# Groundwater Application Review Summary Form

Application # G- 19413

GW Reviewer Joe Kemper Date Review Completed: 7/31/2024

**SUBJECT: Scenic Waterway Interference & General/Local Surface Water Evaluation for Deschutes Ground Water Study Area**

Hydrograph One: Water Level Elevations Across the City of Bend

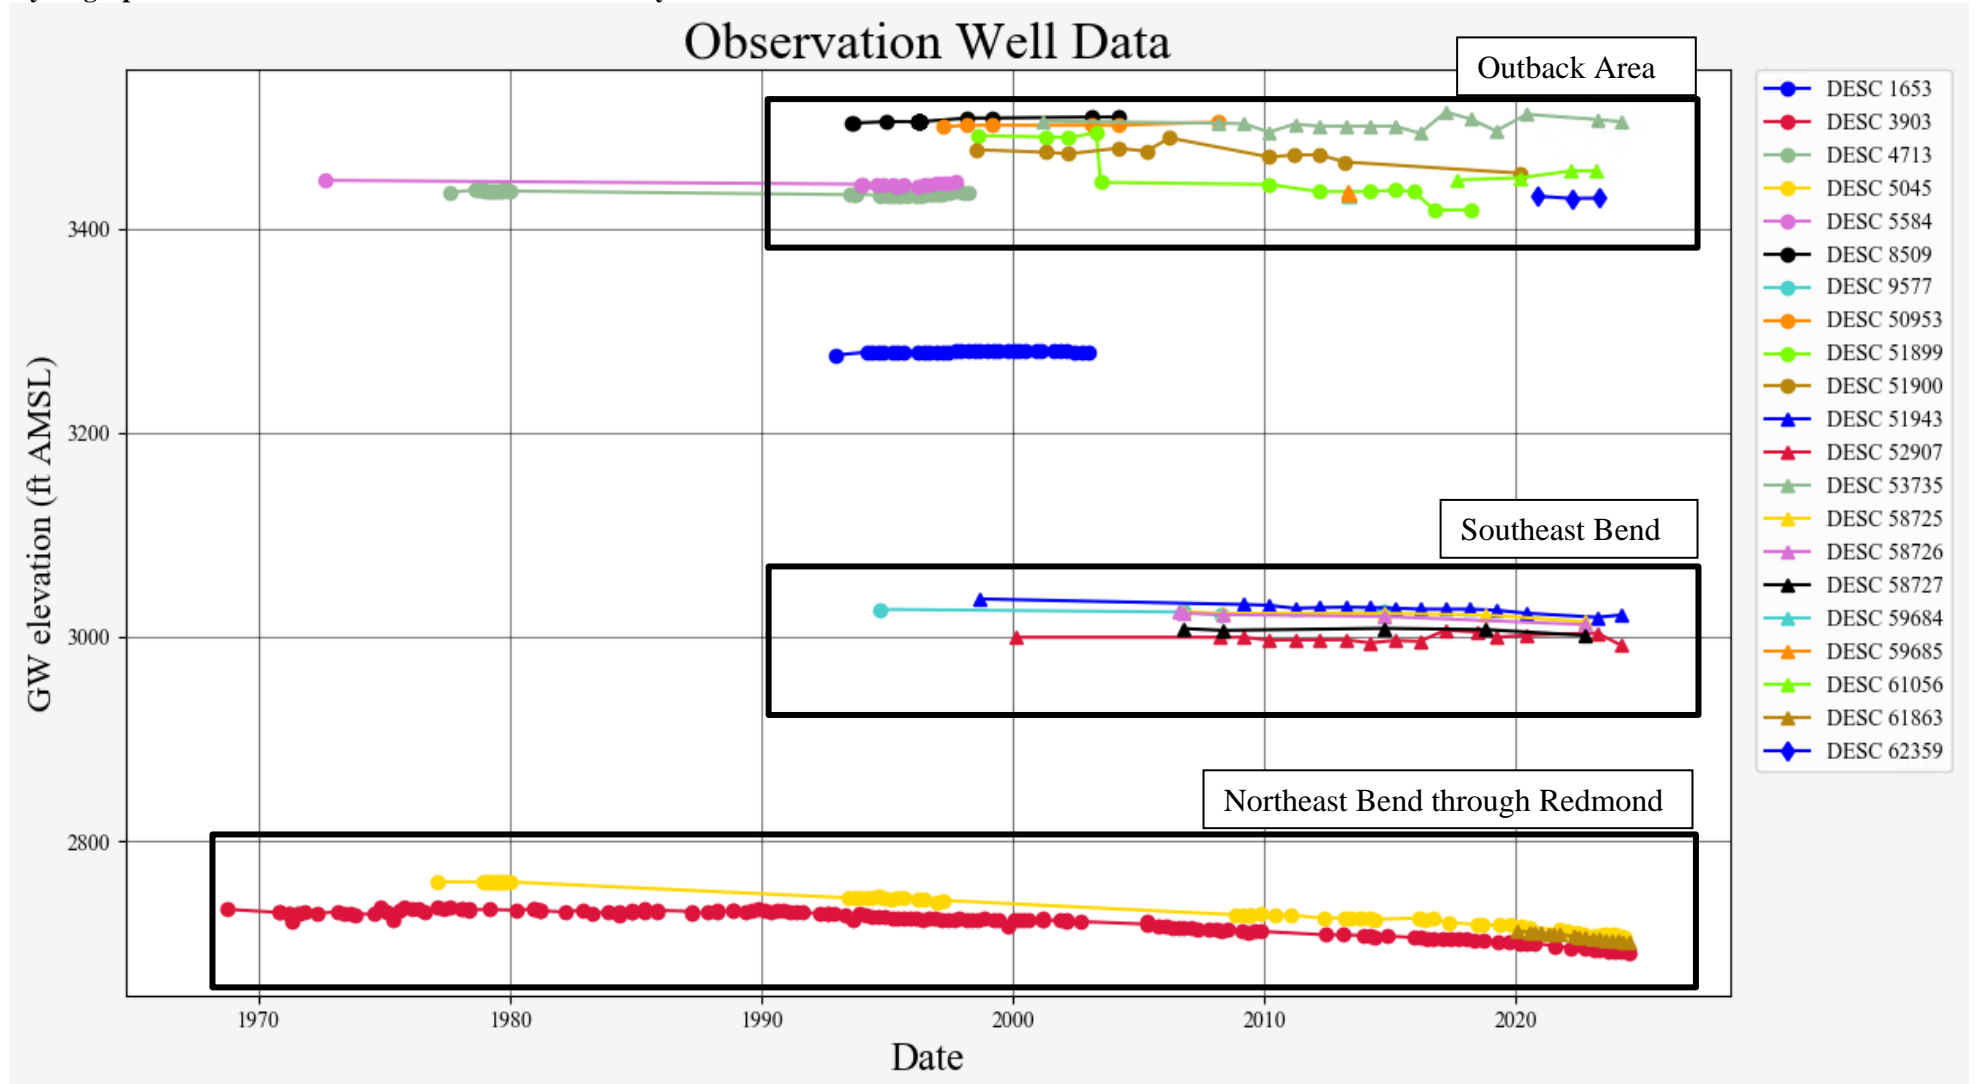
- B3. **Groundwater availability remarks:** All five POAs would access the Deschutes regional aquifer. Well 1 (DESC 52907) and Well 2 (Proposed) are located immediately adjacent to Pilot Butte within Bend city limits. DESC 52907 is drilled to a similar depth and has a similar water level elevation (2990-3025 feet AMSL) as wells adjacent to Pilot Butte (DESC 8499 & DESC 58778) through the Knott Landfill southeast of Bend (see Hydrograph 3). The proposed Neff Well will likely encounter similar hydraulic conditions as the applicant's Pilot Butte well field. Available water level records indicate that this group of wells declined approximately 10-15 feet since the mid-1990s. This decline is notable but is less than the 40-45 feet of declines between Bend and Redmond that has raised Capacity of the Resource issues.

Hydrograph Four: Outback Wells

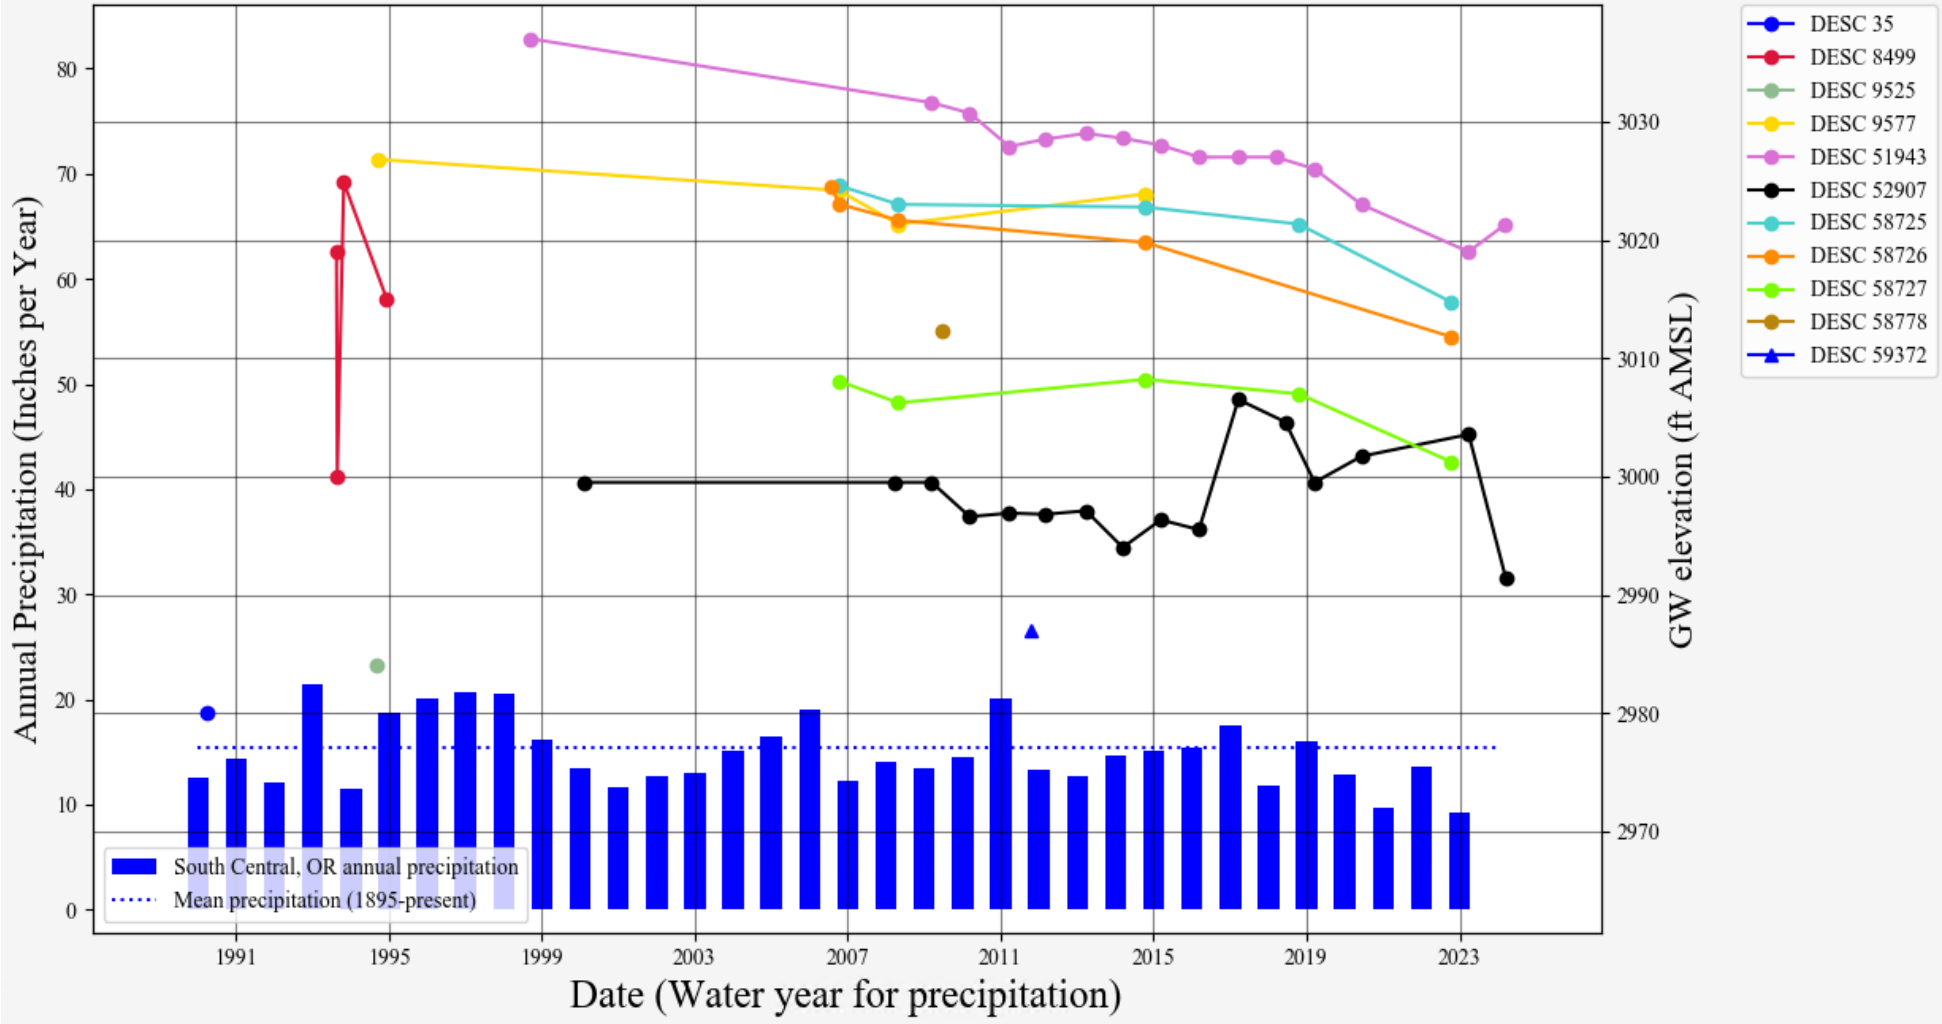
Well 3 (DESC 57760), Well 4 (proposed), and Well 5 (proposed) are located west of Bend in the Outback site. This site is upgradient in the flow system with water level elevations between 3420-3520 feet AMSL. Water level trends are somewhat varied, with stable water levels in some observation wells while other wells show 20+ feet of decline. As noted above, the declines are concerning but are lower in magnitude than the declines in the center of the basin that had raised Capacity of the Resource issues. Gannett and Lite (2013) showed that declines across the basin in 2008 were caused (in varying proportions) by decreased climate recharge, increased pumping, and canal piping projects.
